## Wisconsin Department of Transportation

**Proposal #23: Project 1170-00-74, WISC 2016 036**  
**Wausau - Merrill**  
**B-37-155, 158, 159**  
**USH 51**  
**Marathon County**

This is Addendum No. 02, which provides for the following:

## **ADDENDUM NO. 02**

Addendum No. 02  
ID 1170-00-74  
Added Sheet 10A  
January 8, 2016

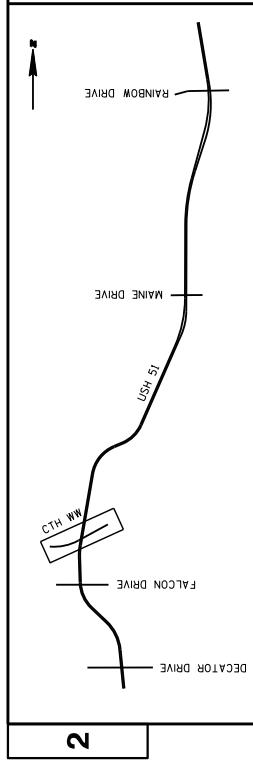
Added Plan Sheets	
Plan Sheet	Plan Sheet Title (brief description of why sheet was added)
10A	Typical Section-to show typical section on CTH WW
92A	Plan- to show permanent work on CTH WW
211A	B-37-158 Sheet 5A Temporary Structure (2 of 2)- Sheet was added to provide elevation and section of temporary wire faced wall.

Addendum No. 02  
ID 1170-00-74  
Revised Sheet 57  
January 8, 2016

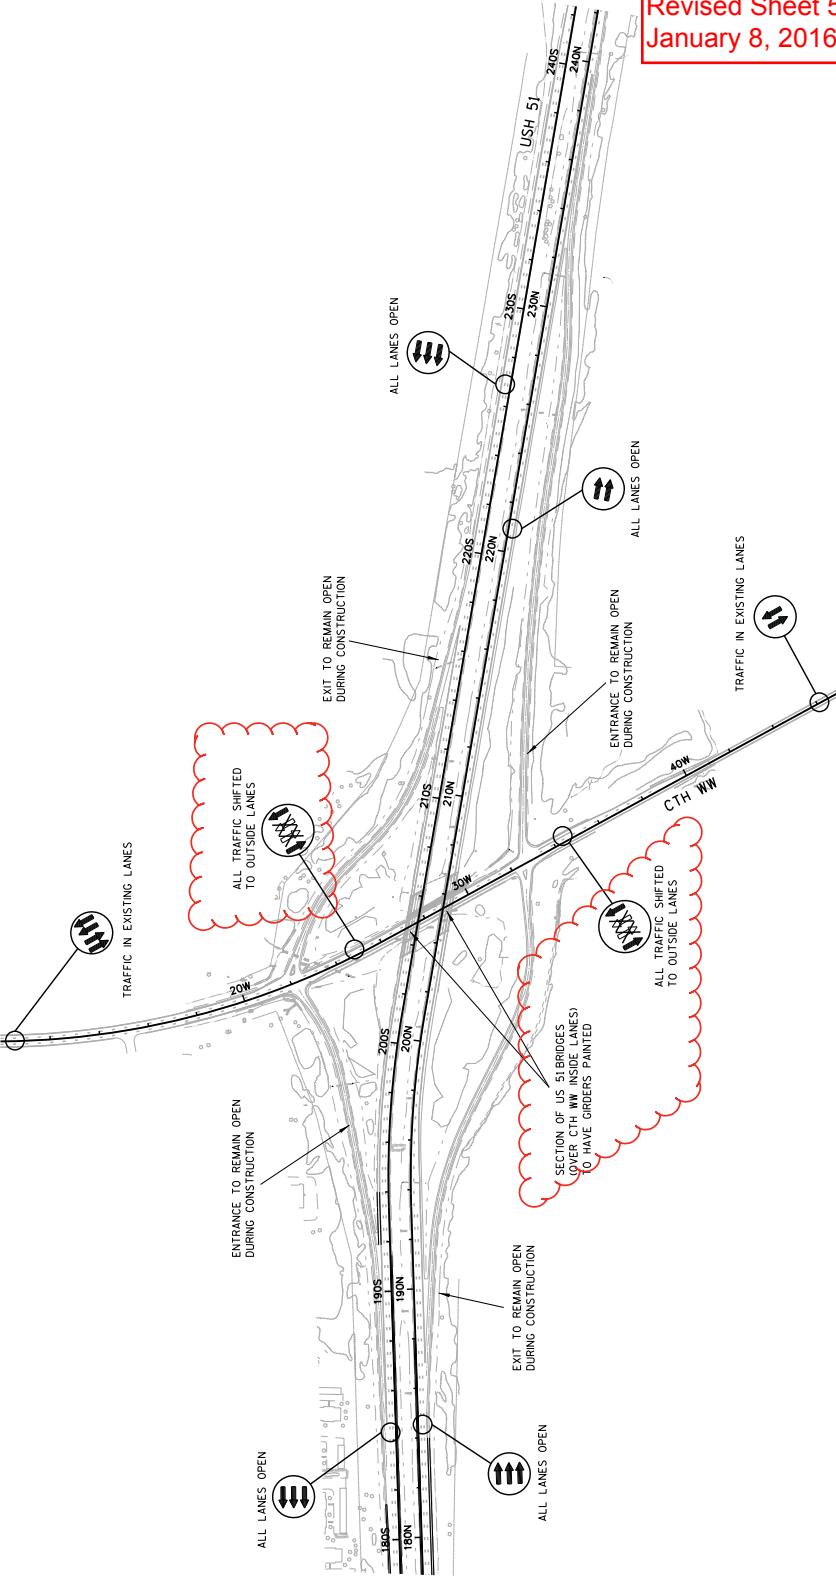
Revised Plan Sheets	
Plan Sheet	Plan Sheet Title (brief description of changes to sheet)
57	Traffic Control Overview 6A- changed sheet for the traffic now being on the outside lanes instead of the eastbound lanes
58	Traffic Control Stage 6A- redesigned and cadded sheet for traffic driving on the outside lanes
59	Traffic Control Overview 6B- changed sheet for the traffic now being on the inside lanes instead of the westbound lanes
60	Traffic Control Stage 6B- redesigned and cadded sheet for traffic driving on the inside lanes
71	Miscellaneous Quantities-changed removing pavement quantity
73	Miscellaneous Quantities-added concrete pavement 9-inch quantity, changed base aggregate 1 ¼ inch, asphaltic material PG58-28, tack coat, and HMA pavement type E-3 quantities
80	Miscellaneous Quantities- updated traffic control drums, traffic control barricades type III, traffic control warning lights type A, and traffic control signs quantities

STAGE 6A - TRAFFIC: TRAFFIC SHIFTED TO OUTSIDE LANES

Addendum No. 02  
ID 1170-00-74  
Revised Sheet 58  
January 8, 2016

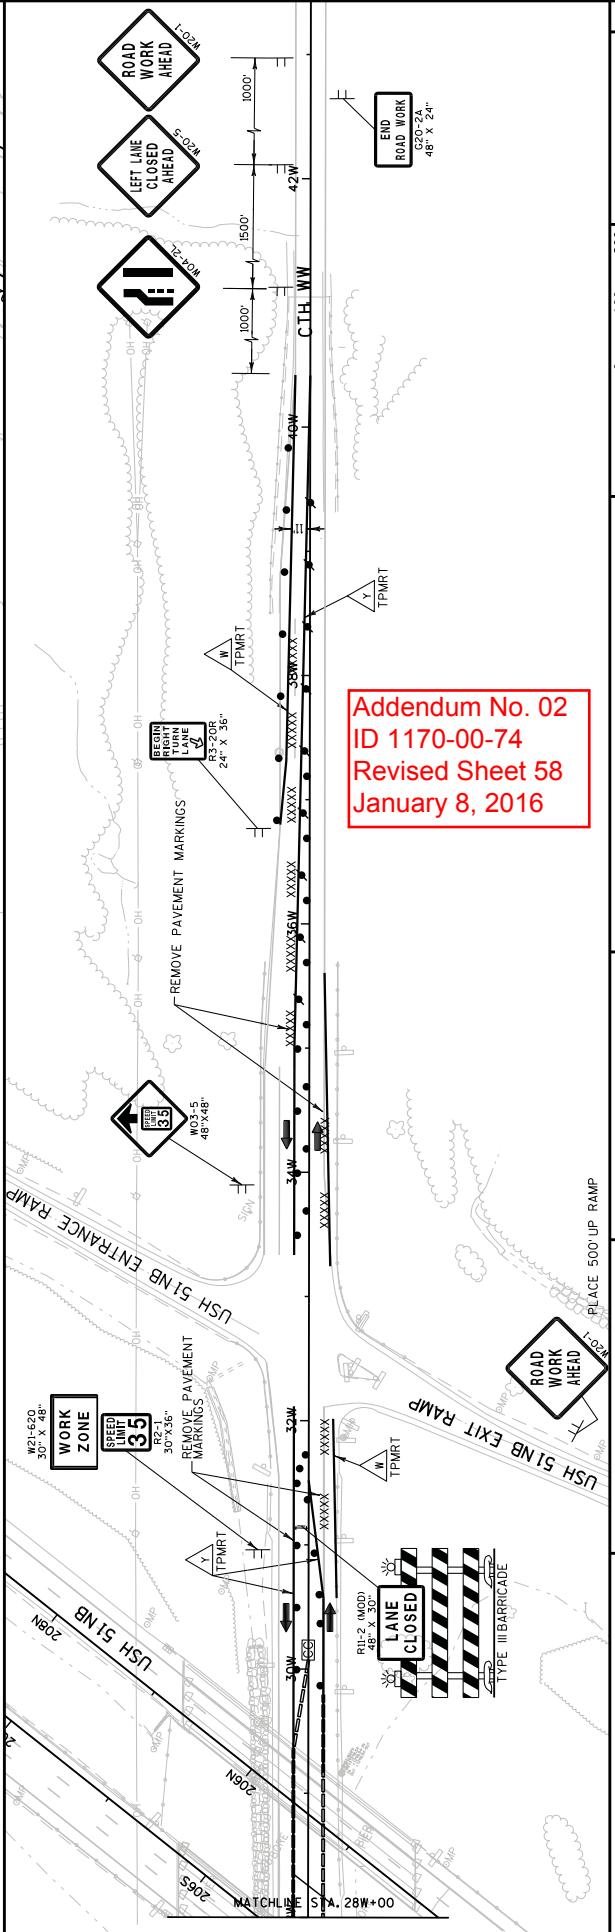
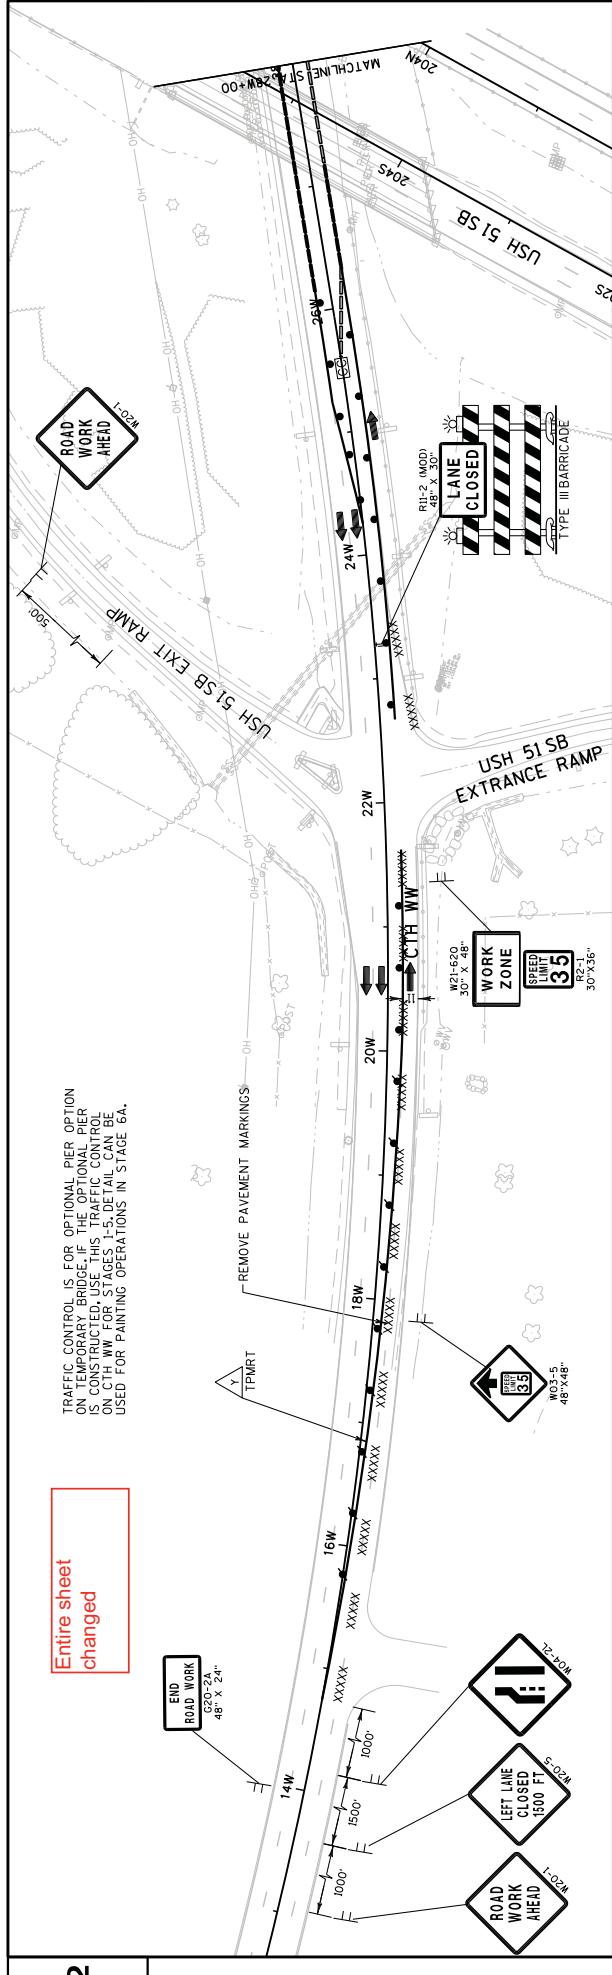
Entire sheet  
changed
